EEG-50

**IMPLICATIONS OF OIL AND GAS LEASES
AT THE WIPP ON COMPLIANCE WITH
EPA TRU WASTE DISPOSAL STANDARDS**

**Environmental Evaluation Group
New Mexico**

June 1992

Figure 7. Oil and Gas Leases Within the WIPP Site according to the DOE FEIS, (U.S. DOE, 1980, Figure 8-6, reproduced with permission).

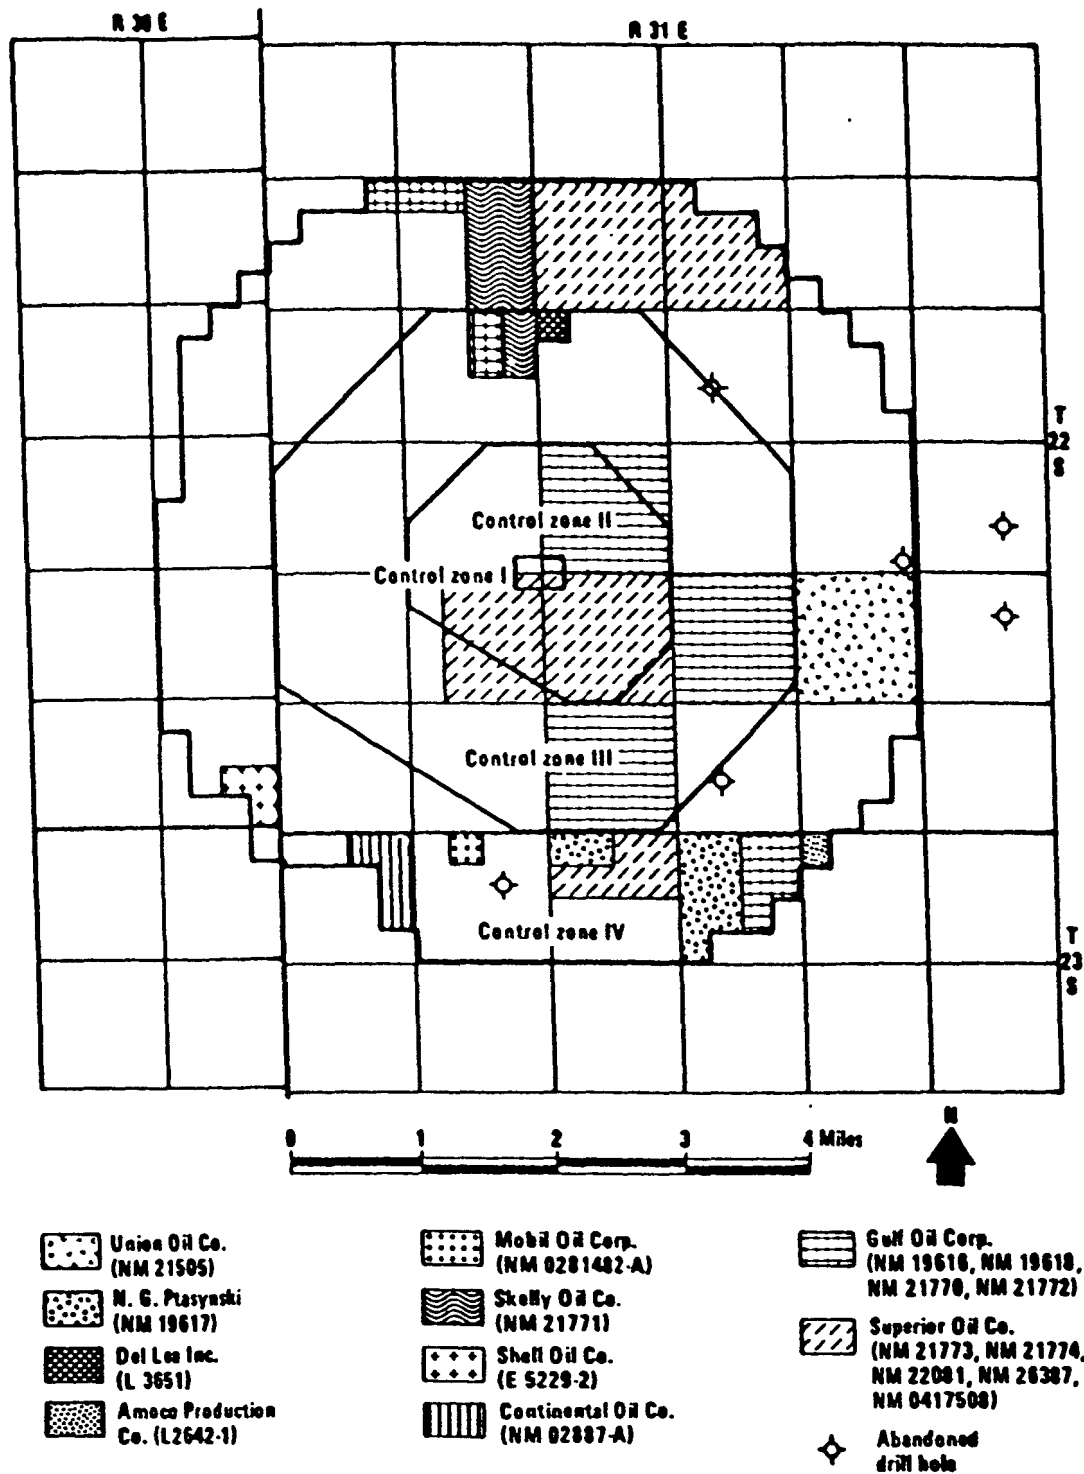
The WIPP Final Environmental Impact Statement (U.S. DOE, 1980) identifies the gas and oil leases held by ten companies in March 1979 at the WIPP Site. Figure 7 (reproduced from the 1980 WIPP FEIS) does not show the Bass and Conoco leases on Section 31. While those two leases were condemned in February 1979 from the surface to 6,000 feet (1829 meters), the oil and gas leases below 6,000 feet (1829 meters) did remain valid.

Figure 8. 1986 Operable Natural Gas and Oil Wells, within 10 Mile Radius (WIPP FSAR, U.S. DOE, 1990a, Figure 2.2-1, reproduced with permission).

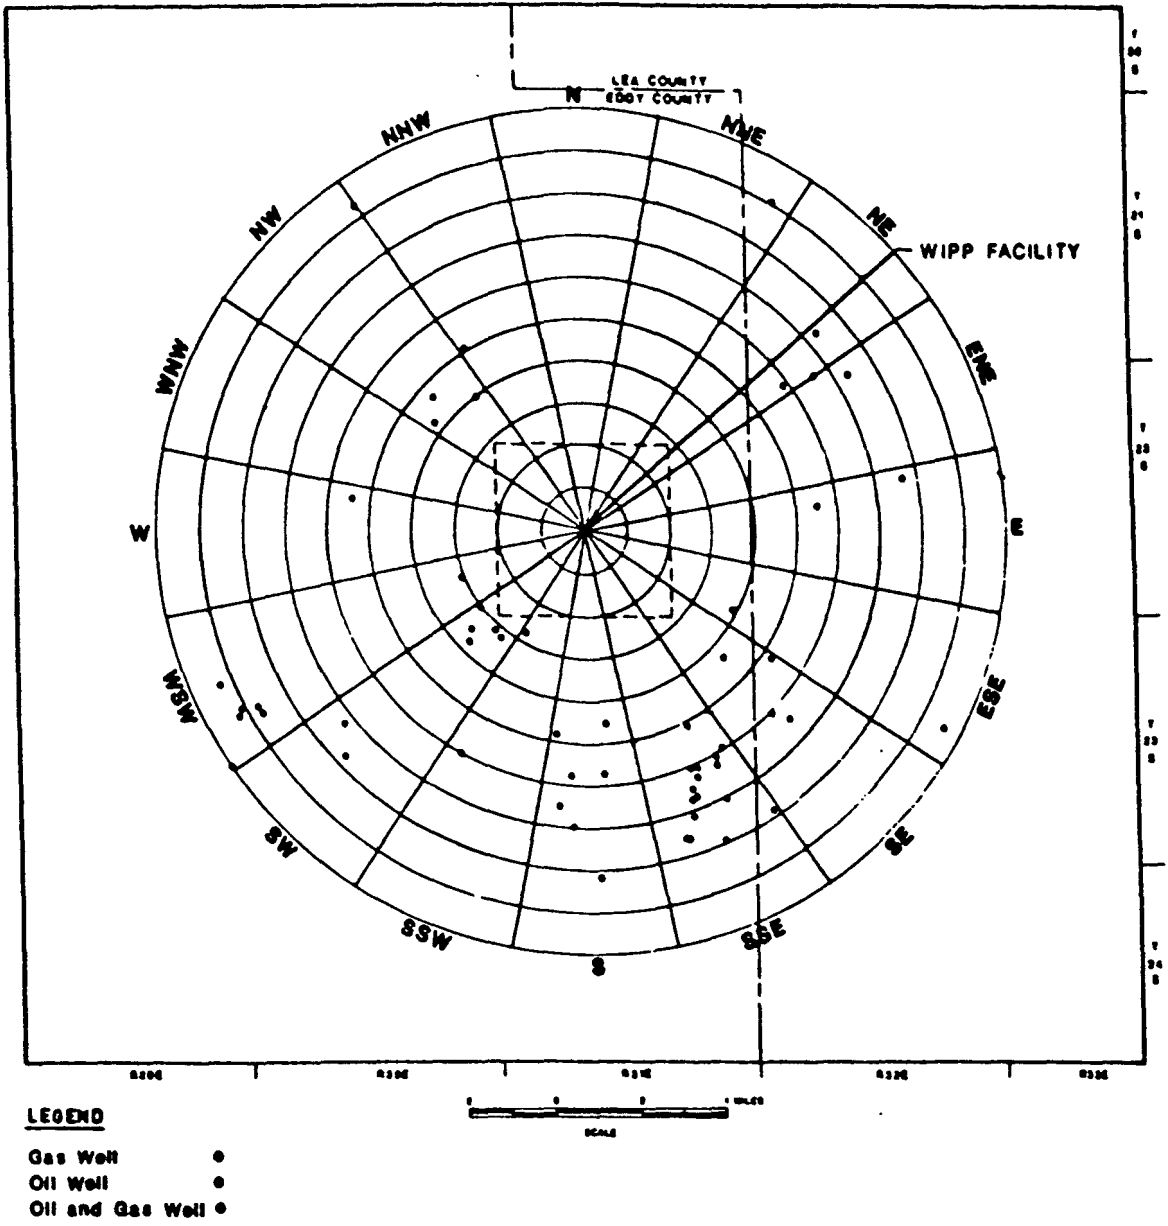
Furthermore, Figure 2.2-1 (Figure 8 in this report) of the WIPP FSAR fails to show all of the 1986 operable natural gas and oil wells within a ten mile (16.1 kilometers) radius. This figure shows seven wells just outside the southwest corner of the site - James Ranch Unit Nos. 1, 3, 4, 7, 10, 11 and Hudson Federal No. 1. James Ranch Unit No. 3 appears to be plotted in the wrong location. At least two wells, James Ranch Unit Nos. 13 and 14 shown in Figure 9, both slant drilled wells, are not shown in the WIPP FSAR. James Ranch Unit No. 13 and James Ranch Unit No. 14 were not only operable, but each was producing through the entire year of 1986, as shown in Figures 10 and 11.
